MODIFICATION REQUEST:

Concept Plan for Residential Development

**5 Whiteside Street and 14 and 16 David Avenue,
North Ryde**

Secretary's Environmental Assessment Report
Section 75W of the
Environmental Planning and Assessment Act 1979

Figure 2: Extent of proposed building envelopes and approved building envelopes (red dotted line) and indicative first floor apartment layout (Source: proponent's application)

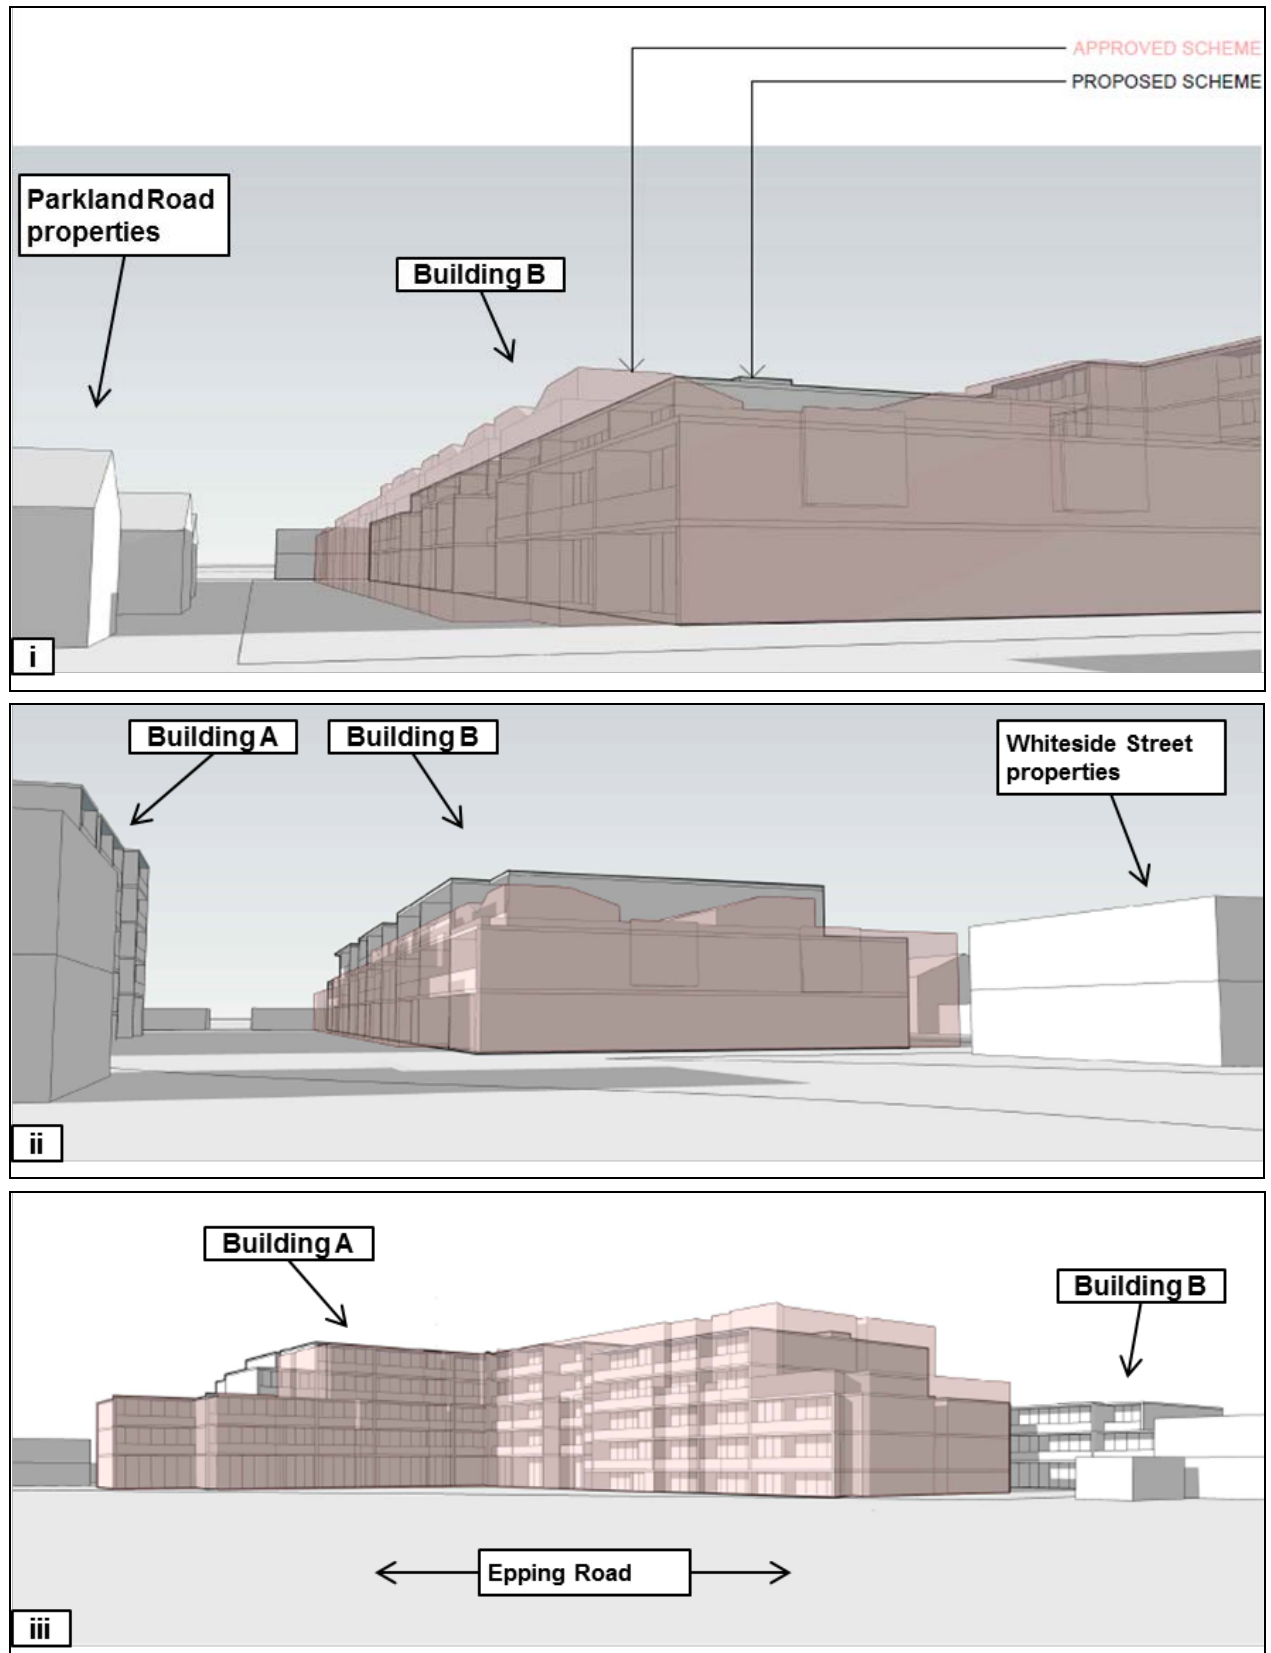
Comparison images of the approved and proposed modified concept plan are shown at **Figures 2 and 3**. Further details of the proposed modifications are provided at **Appendix A**.

Figure 4: Approved envelope heights, Building A as revised by the PAC (Source: MP10_0165 Condition B1)

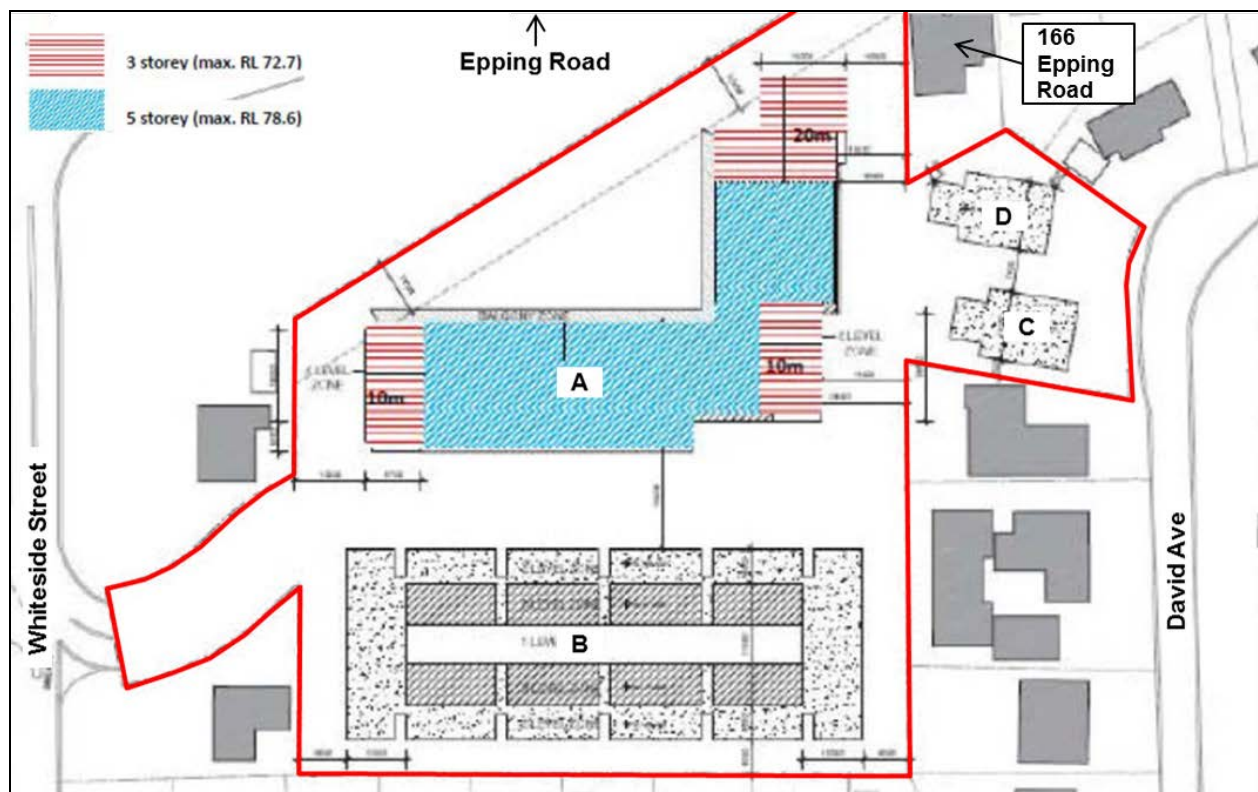
The PAC, however, was of the view that a six storey building in this location was excessive. To improve the transition to the surrounding area the PAC reduced the height of Building A to part three, part five storeys (refer to **Figure 4**).

Figure 5: Proposed third and fourth floor of building envelope A, indicative apartment layouts and western elevation. The extent of approved building envelope is shown by dotted red line (Source: proponent's application)

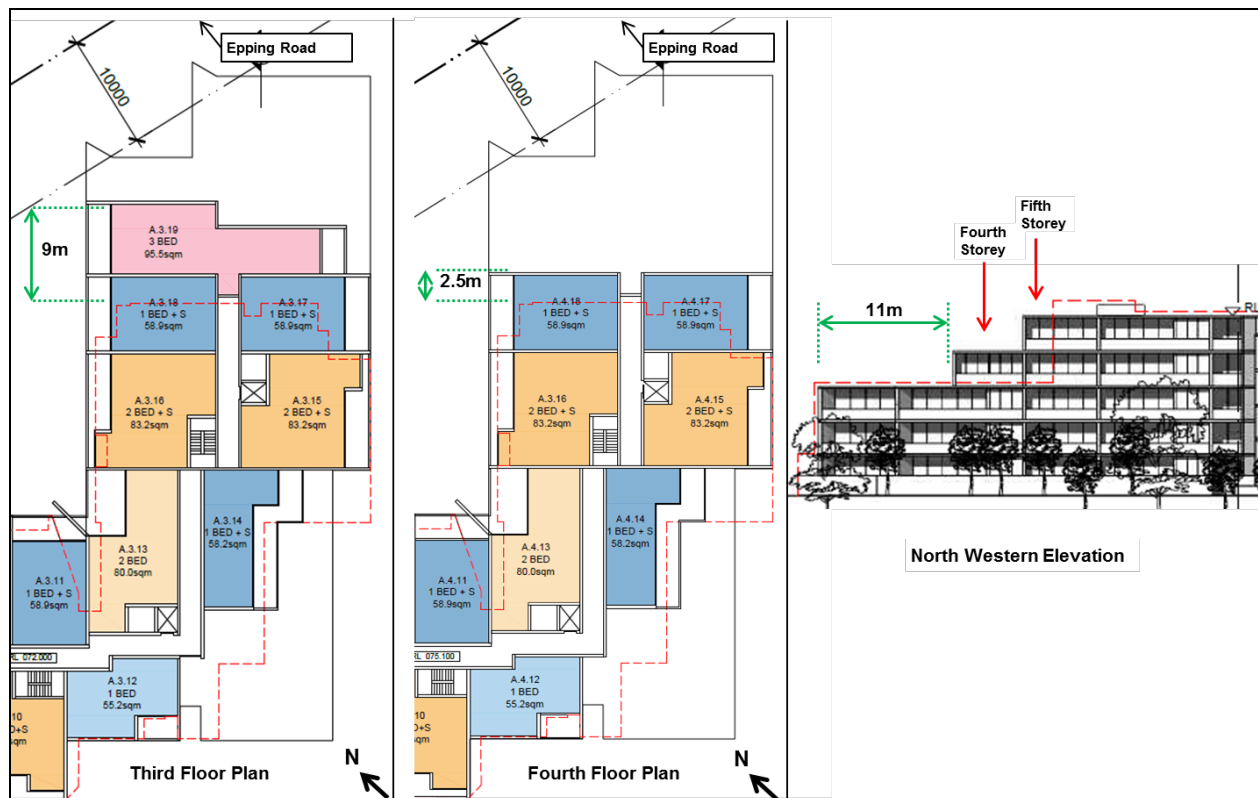
As approved the north east wing of building envelope A is three and five storeys. The proposal seeks an expansion of the building envelope in this location, providing for an additional step in building height at the fourth storey and minor enlargement at the fifth storey (refer to **Figure 5**). The proposal also seeks minor reductions in the height of the north west wing of the building envelope as shown at **Figure 3(iii)** and other minor expansions and reductions of the building envelope depth.

The Department is of the view that the proposed amendments to building envelope A are acceptable, as:

- the additional fourth storey element of the north east wing is setback 11 metres from the three storey building element below and maintains an appropriate transition of built form to the neighbouring low rise buildings;
- the fourth storey element would be located 20 metres from Building D and 17 metres (obliquely) from 166 Epping Road and is therefore consistent with the RFDC recommended 12 metre minimum building separation requirements for buildings up to four storeys;
- the amendments would not result in an increase in the overall height of the building envelope;

- shadow analysis has confirmed that the alterations would not have an impact on solar access to neighbouring residential properties; and
- the combination of the expansion and reductions of building the would not adversely impact on views along Epping Road.

Figure 6: The distance of the approved (blue) and proposed (green) first floor building envelope from the rear of the neighbouring Parkland Road properties. The extent of approved building envelope is shown by dotted red line (Source: proponent's additional information)

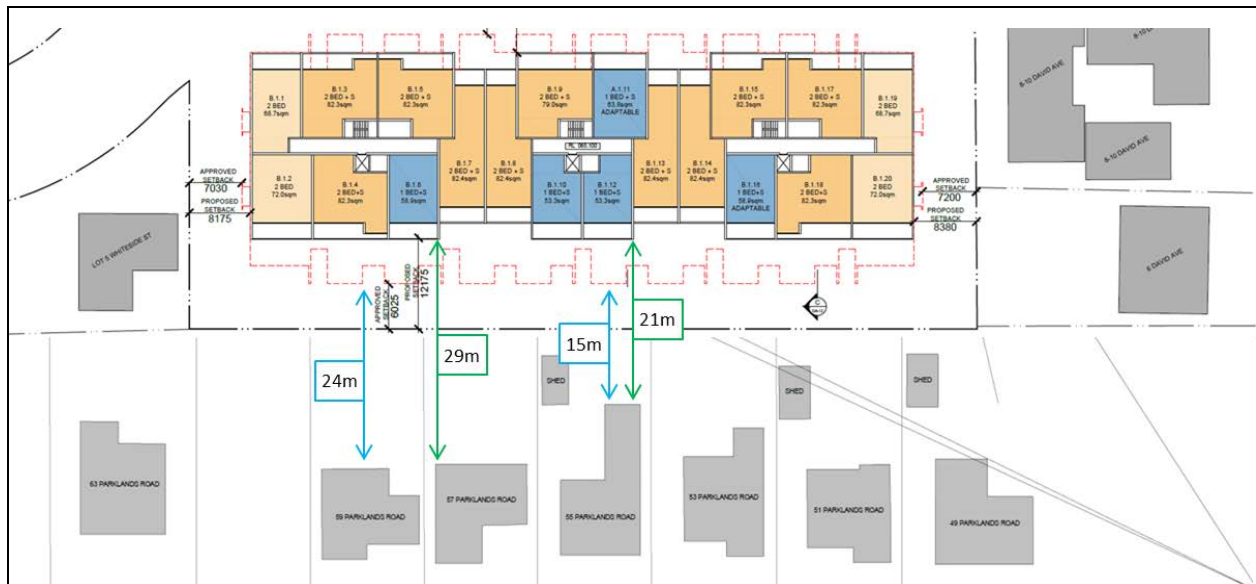
The Department notes that the application proposes to significantly reduce the depth of building envelope B. As a consequence, it is approximately six metres further away (a total of 21 metres) from the closest rear elevation of the neighbouring residential buildings fronting Parklands Road (refer to **Figure 6**).

As approved, the rear elevation of building envelope B is located between 15 and 24 metres from the rear elevations of properties fronting Parklands Road and six metres from their rear boundaries (refer to **Figure 6**).

The Department notes that the amendment to building envelope B achieves a minimum building separation of 21 metres, which exceeds the RFDC recommended separation distances and also the draft Apartment Design Guide recommended setbacks to boundaries (minimum 12 metres).

The Department is of the view that the reduction of the building envelope depth and consequential increase in the distance between the rear boundary and the rear elevations of properties fronting Parklands Street (an additional six metres), reduces the visual and amenity impacts of the building on the Parklands Street properties. Furthermore, substantial deep soil planting including screening planting will be provided along the boundary. On this basis privacy may be maintained between properties and therefore there is no justification for the prohibition of balconies.

Figure 7: Proposed top floor (level 2) building envelope and the indicative apartment layout. The extent of approved building envelope is shown by dotted red line (Source: proponent's application)

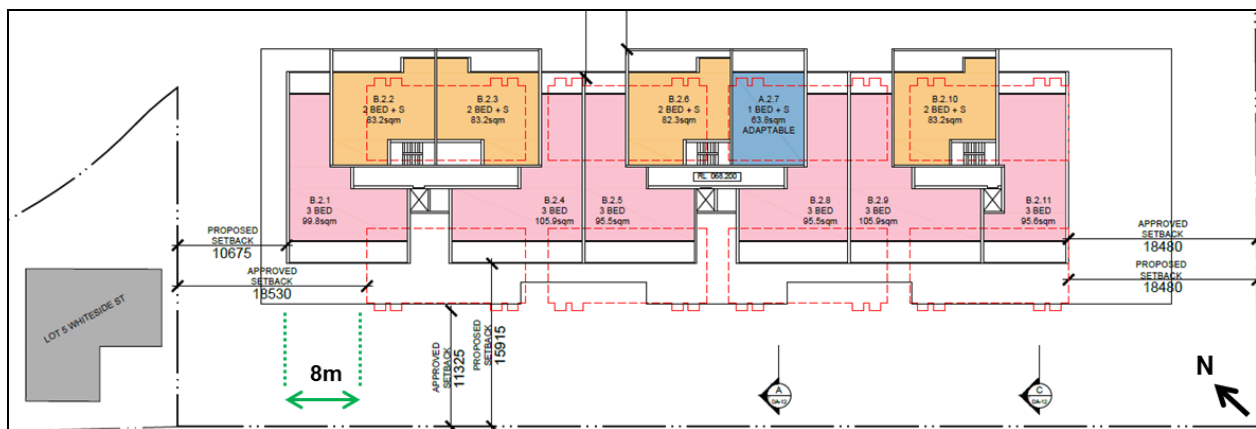
As approved, building envelope B is three storeys high. The ground and first level are 33 metres deep and setback six metres from the rear boundary of properties fronting Parklands Road to the south (refer to **Figure 2 and 6**). The uppermost floor (level 2) includes a six metre setback from the level below (front and back) and comprises eight separate pop-up roof extensions (refer to **Figure 7**). The proposal seeks to amend the envelope by:

- reducing the building envelope depth from 33 to 25 metres;
- replace the eight separate roof extensions at level 2 with an entire top floor, including setbacks; and
- extend the building envelope of level 2 to the west by eight metres, closer to Whiteside Street.

The amendments to building envelope B, including the expansion of uppermost floor, are acceptable as:

- the reduction in building envelope depth results in an increased setback from neighbouring dwellings (minimum 21 metres), which will reduce the building's perceived scale and bulk when viewed from the Parklands Road properties;
- the uppermost floor will be setback 2.5m from the western edge of the building and 12 metres from the rear of 5 Whiteside Street and is therefore consistent with the RFDC recommended 12 metre minimum building separation requirements. The Department further recommends a FEAR to prevent balconies in this location to ensure privacy is maintained;
- as discussed at **Section 5.5**, the proposal would not result in any adverse overlooking;

- shadow analysis submitted with the application has demonstrated that the solar access of neighbouring properties is improved; and
- the front and rear elevations of the building envelope are divided into bays, which would provide for sufficient building articulation and therefore add visual interest.
